UNITED STATES PATENT AND TRADEMARK OFFICE

APPLICATION NO.	FILING DATE	FIRST NAMED INVENTOR	ATTORNEY DOCKET NO.	CONFIRMATION NO.
10/663,554	09/16/2003	Bret M. Berry	31132.172	2585

Office Action Summary

DETAILED ACTION

**FIG. 3**

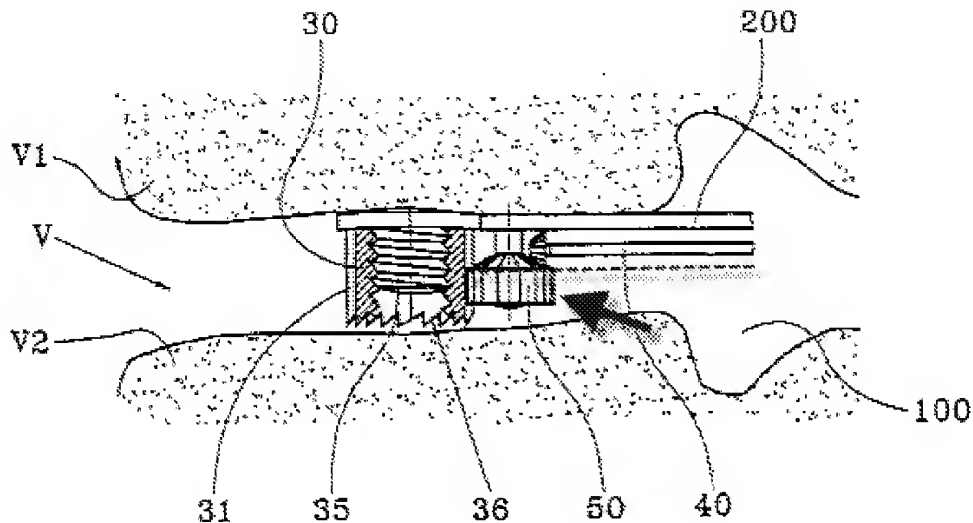
Claims 23-24 and 27-29 are rejected under 35 U.S.C. 102(e) as being anticipated by Zacuto (US Patent 6,692,495). Zacuto discloses an axle (40) defining a first axis and having a proximal end (towards the gear end, Fig. 3) and a distal end (opposite) and wherein the axle is adapted to rotate about the first axis, a first gear and

a second gear (50, Fig. 3) connected to the axle and also wherein a first gear is adapted to rotate about the first axis, and wherein the gears are attached to the proximal end of the axle. A second gear rotates about a second axis (axis shown in Fig. 3). See below.

It is noted that the top portion of 50 shown above is considered the second gear and the second bottom portion (arrow) is considered an engager device with a toothed section. This engager device is fixedly secured to the gear and has conjoint rotation therewith about a second axis. Fig. 4 shows a top view with teeth or cog-shaped projections that extend outwards and that are capable of engaging an implant. These sections rotate the implant portion (30/35). Each end could be considered a plated portion and a threaded connection moves them relative, and further has an outer casing (200).
